Statement of objection to SSD-82395459

Reference: SSD-82395459

Residential Flat Buildings (x 2) at Burgoyne Street, Burgoyne Lane and Pearson Avenue, Gordon

Figure 2 Misleading junction configuration.

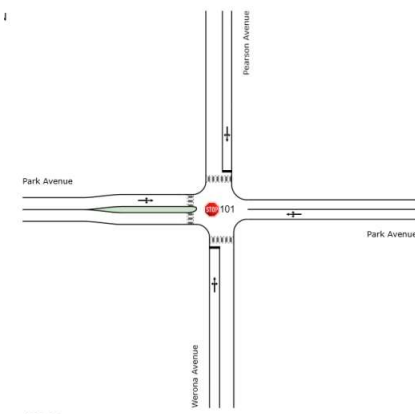
The representation of the junction is misleading in “Appendix 10: traffic impact assessment” is misleading. It is not a cross junction. This is because Pearson Avenue and Werona Avenue is not aligned, as illustrated in the google map below.

For traffic going between Pearson Avenue and Werona Avenue, a car must turn to Park Avenue first before entering Werona Avenue and vice versa. This is a common route for the local residents to drop people to the station. However, Park Avenue is prone to be jammed because of the traffic light backlog to clear the car from Park Avenue to Pacific highway. Once the backlog reaches the junction of Park Avenue/Werona Avenue. The local traffic will grind to a halt.

It is unclear what are the assumption and parameters used in the traffic modelling. As a minimum, the following parameters must be included.

- Time for a car to clear from Pearson to Park Avenue, and vice versa.
- Time for a car to clear from Park Avenue to Werona Avenue, and vice versa.
- Time for a car to clear from Park Avenue to Pacific highway, and vice versa.
- Time for a person or a group of people to cross Park Avenue, Werona Avenue, Pearson Avenue
- Probability a person is crossing the Park Avenue or Werona Avenue or Pearson Avenue.

The traffic model is at best lacking details, or worst misleading.
